Re: High School Additions and Renovations Phase 2

Subject: Revised - Change Proposal – Feeder to Generator 2 Service Panel 0 RFI EC003

RFI #:	Date:	Discipline:	Description:
EC-03	9/30/2025	Electrical	Generator Load Center

Project Name: North Penn High School Add/Reno – Bid Pack 2 Project No.: SG 22-036.2

Drawing Number:
BP2-E301.B

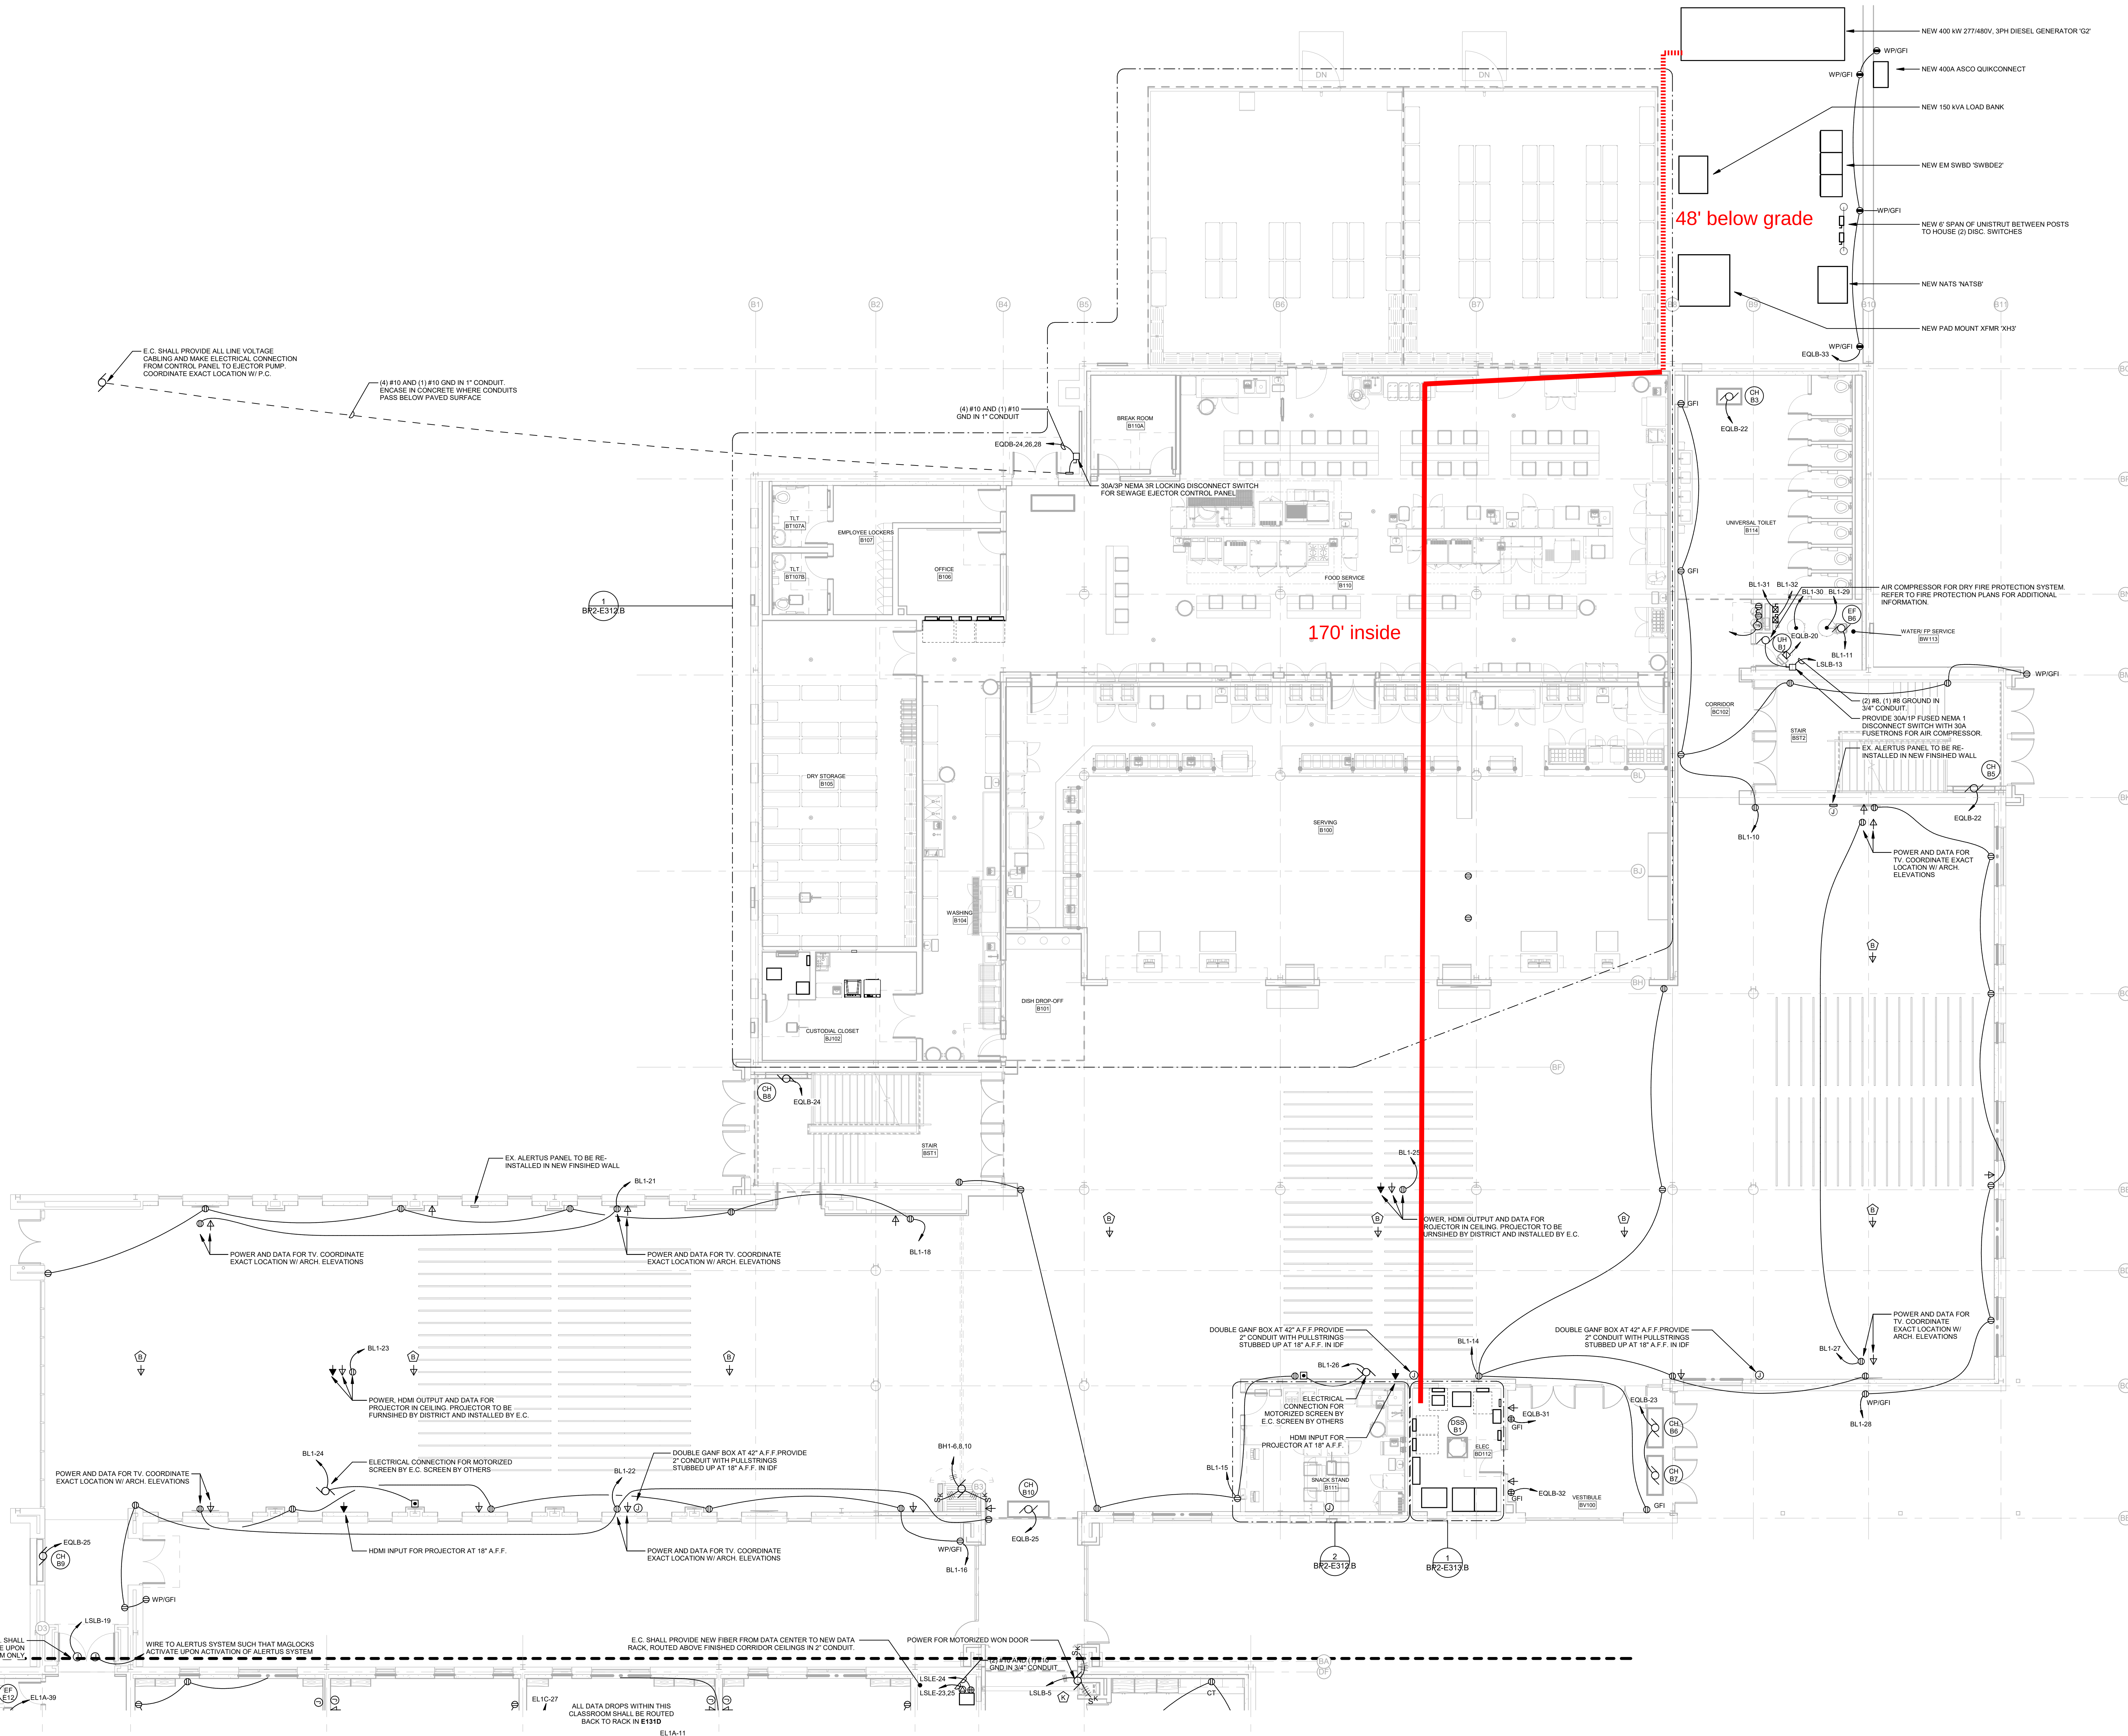
Drawing E502 indicates a 100a load center to be integral to the 600 kw generator labeled 'G1'. The 500kw generator labeled 'G2' does not have a note indicating an integral load center. Spec page 263213-15 section 6 sub section 5 for generators calls out a load center to be integral to the generators. Is generator G2 to be supplied with an integral lead center? If so please provide panel designation, wire size, and conduit size.

1. RFI Number 003	Responsible Contractor Wescott Electric	Date 09/30/2025
Description: Drawing E502 indicates a 100a load center to be integral to the 600 kw generator labeled 'G1'. The 500kw generator labeled 'G2' does not have a note indicating an integral load center. Spec page 263213-15 section 6 sub section 5 for generators calls out a load center to be integral to the generators. Is generator G2 to be supplied with an integral lead center? If so please provide panel designation, wire size, and conduit size.		
References: 263213		
Requested By: Darrell Putnam		Date 09-29-25

Generator 'G2' shall be provided with a 100A 120/208V integral load center, per specification to feed all generator accessories as indicated in note at generator 'G1' on sheet BP2-E502. Load center shall be fed out of new 100A/3P breaker in provisional spaces 'EQLB-36,38,40' and wired with (4) 3/0 and (1) #4 gnd in 2-1/2" conduit.

2. A/E Response, or Comments (if applicable): Generator 'G2' shall be provided with a 100A 120/208V integral load center, per specification to feed all generator accessories as indicated in note at generator 'G1' on sheet BP2-E502. Load center shall be fed out of new 100A/3P breaker in provisional spaces 'EQLB-36,38,40' and wired with (4) 3/0 and (1) #4 gnd in 2-1/2" conduit.		
A/E (Signature):	Date	Contract Document Impact ☐ Yes ☐ No Revisions Attached { ☐ Yes ☐ No
